August 29, 1988

Recommended Connector Positions Signal and Power, Rev 2

# SCSI CONNECTOR ORIENTATION FOR HORIZONTAL INTERNAL DEVICE

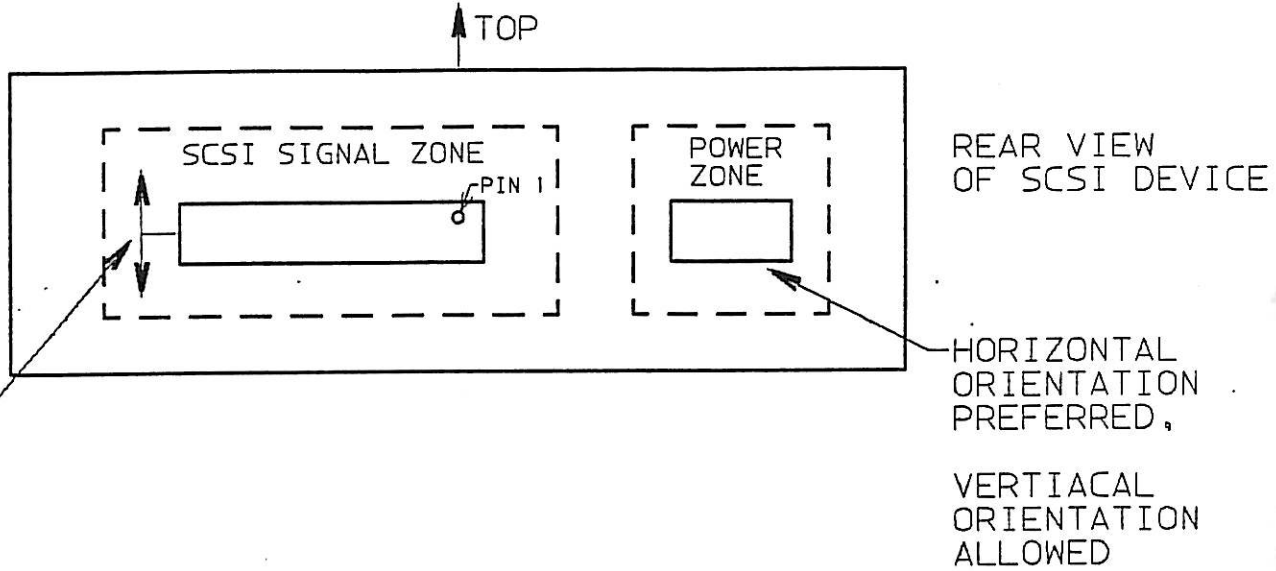
Define the preferred locations of the data and power connectors on the rear of the devices in the SCSI specification. Figure (1) defines the locations as proposed. In a rear view of a device; the power connector is to the right and the data connector is to the left. Connector Pin #1 identification is also established as noted in figure (1).

Specifying both of the above parameters assures minimum cable folds and crossovers thereby enhancing the implementation of SCSI. This proposal is in the form of a recommendation providing preferred locations and orientations for the subject connectors. Compliance/Conformity to SCSI 2 shall not be contingent upon implementation as described in figure (1).

NOTE 1: SIGNAL CONNECTOR REQUIRED TO HAVE HORIZONTAL ORIENTATION, MAY BE PLACED HIGH, LOW, OR MID. PORTION OF ZONE.

NOTE 2: DETAIL A AND DETAIL B PROVIDE ALLOWED ALTERNATIVES FOR DEVICES USING AN IN AND OUT SCSI SIGNAL CONNECTOR.

NOTE 3: ONLY THE LOCATION OF THE SCSI A CABLE SIGNAL CONNECTOR IS DEFINED IN THIS RECOMMENDATION.
